STAFF REPORT: FEBRUARY 13, 2024 MEETING
APPLICATION NUMBER: HDC2024-00031
ADDRESS: 1760 WABASH
HISTORIC DISTRICT: CORKTOWN
APPLICANT: GUSTAF ANDREASON, @PROPERTIES
PROPERTY OWNER: SHARIF AFFAS, DETROIT DEVELOPING PROPERTIES, LLC
DATE OF PROVISIONALLY COMPLETE APPLICATION: FEBRUARY 19, 2024
DATE OF STAFF SITE VISIT: FEBRUARY 21, 2024

SCOPE: ERECT ADDITION, DEMOLISH SHED

03/12/2024, 10:00 a.m. – report revised to include new fence and revised exterior design of addition

Far left and far right: staff photos, February 2024. Middle photo provided by applicant.

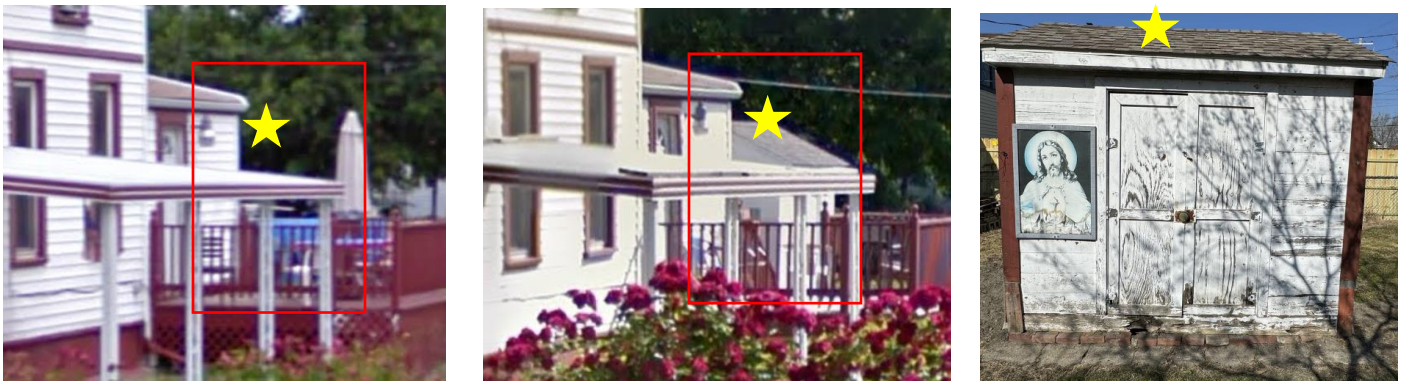
- The application proposes to remove the chimney stack that is in the middle of the house. The stack is not visible from the front elevation nor from an angled view at the sidewalk; it is only visible when standing in the middle of the adjacent vacant lot and from the alley. It is staff's opinion that, with its small width and depth, and low height, the stack is not a prominent feature and doesn't offer historic and architectural significance. The other chimney stack, on the outer rear wall, will be retained.

Applicant photo – south side wall

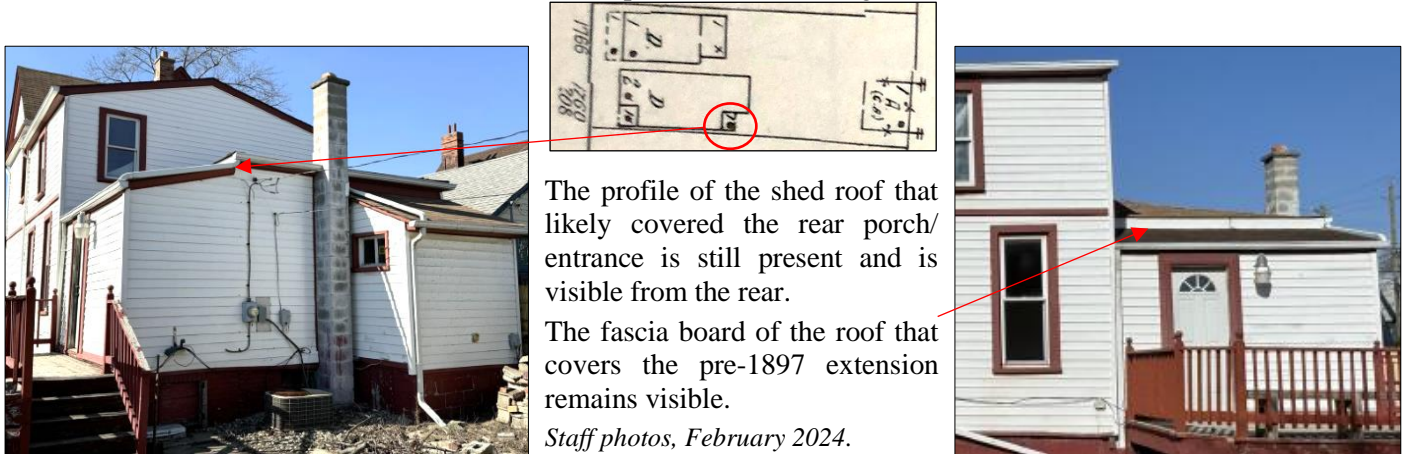
- The rear yard shed was erected between 2009 and 2011; there is no documentation that this shed was approved by the HDC. It is not a historic nor architecturally significant component of the property. The applicant is requesting demolition of this component.

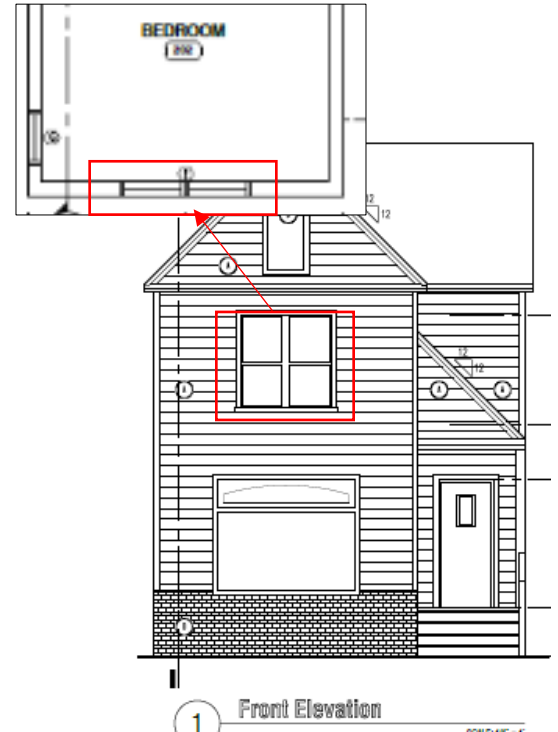
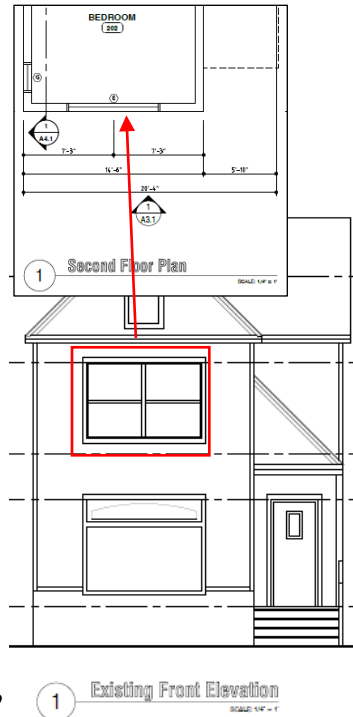
- The dimensions of the existing second floor windows (and central mullion) are typical of late 19th century dwellings and are character-defining features of the dwelling. The drawing of the front elevation shows exceptionally wide windows, and a factory-installed mullion at the second floor, matching the width of the window opening at the first floor. The applicant noted this was not intentional and the existing window openings will remain. The elevation and floor plan will need to be revised with correctly sized openings, including the dimension and placement of the historic mullion.

3/12 – The applicant revised the elevation and second floor plan to reflect the existing second floor window opening.

Right: Corrected elevation/plan to show retention 2nd floor window openings.

Applicant's current elevation drawing of south wall.

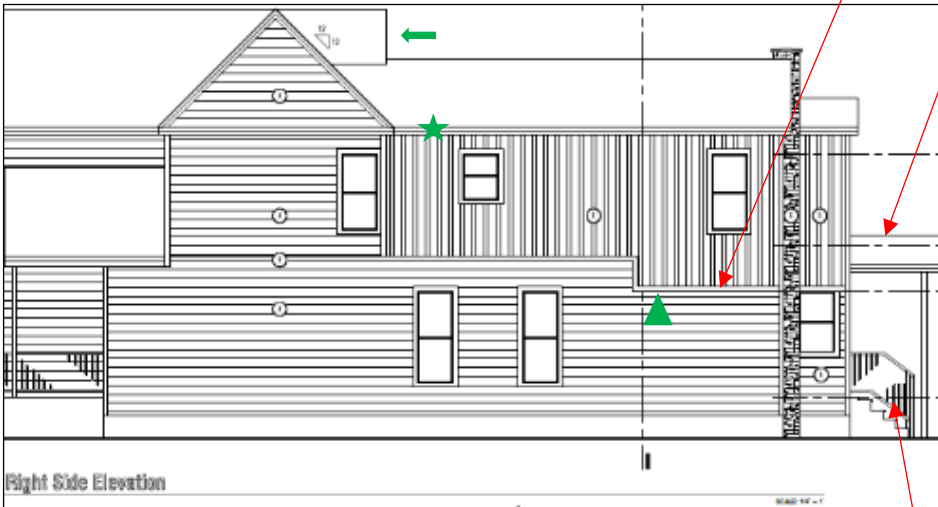
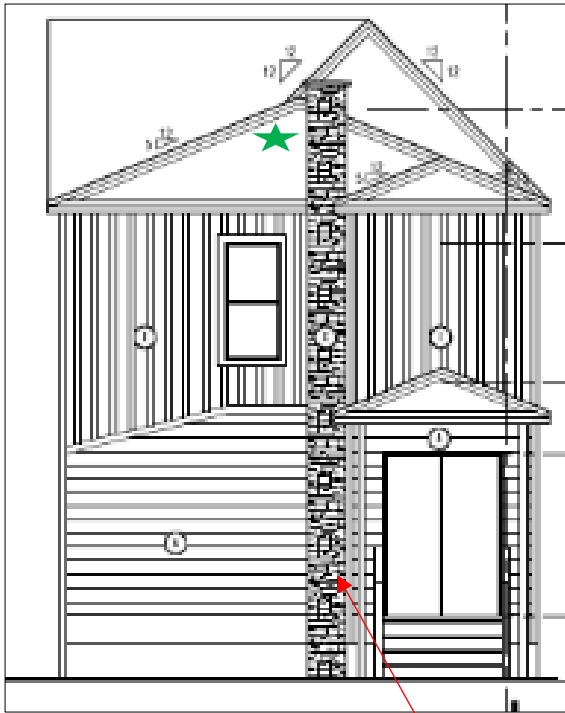
Staff concerns with revised design:

- The height of the eave of the new second floor wall remains in line with the historic house and removes the historic stepped down eave. ★
- The setback of the existing first floor addition hasn't been retained. ▲
The matching eave and solid wall plane of the south wall continue to create a large boxy massing for this highly visible area of the dwelling. As stated on page four, staff didn't find HDC approval of the rear porch expansion and enclosure. However the existing non-historic southern wall at this area retained a small setback from the main structure (see existing condition photo).

- Comparing the original and current application, the revisions of a lower roof height and siding change offer improvements to the design, but it is staff's continued opinion that the massing must be further modified for this project to meet the Standards.

- Vertical siding is specified for the new second floor walls. The proposal shows a lower finish height of the vertical siding to suggest the historic eave height at this wall location.
- The ridge of the addition's roof has been lowered and is well below the ridge of the historic 12-over-12 pitch roof. (Original proposal extended the historic ridge height through the new construction.) ←
- A roof has been added to the rear entrance.

Applicant's current design at rear

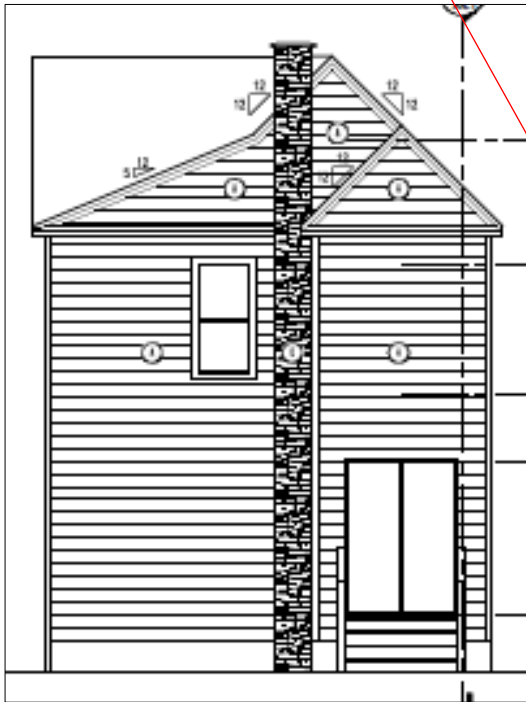
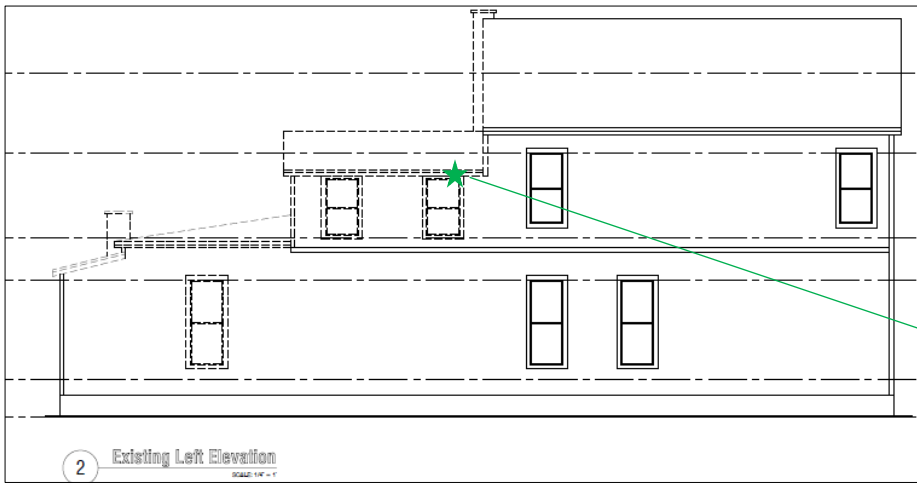
Staff concerns with revised rear wall design:

- *As staff mentioned on the previous page and earlier in the report, the historic massing of 19th century additions / extensions are distinctive character-defining features this property and the district.*
- *Lower roof heights (i.e. ridges, eaves, roof pitch) and at times recessed walls, allow additions/new construction to retain the essential form and integrity of the historic property.*
- *A material sample/cut sheet for the stone veneer at the chimney, confirming stone pattern, profile and color(s) must be submitted for staff review.*

- *Vertical siding is specified for the new second floor walls. The proposal shows a siding detail to suggest an approximation of the former single-story extension's roof.*
- *This view shows how a lower and independent roof retains the essential form and integrity of the historic property, while being differentiated from the original steeply pitched roof. ★*
- *A roof has been added to the rear entrance.*

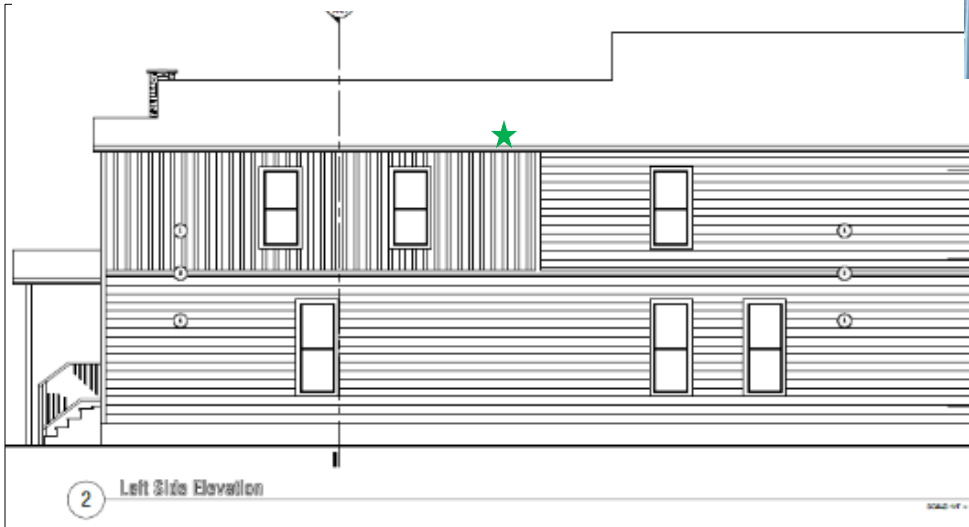
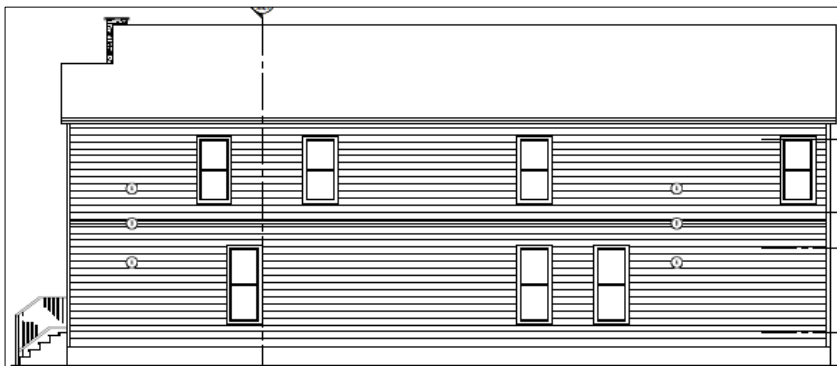
Staff concerns with revised rear wall design:

- Similar to the previously discussed south and east walls, a lower eave height should carry around from the other elevations. This would match the existing historic condition, as noted in the existing north wall drawing and photograph. ★

- New details for north-side wall:
- Vertical siding is specified for the new second floor walls.
 - A roof has been added to the rear entrance.
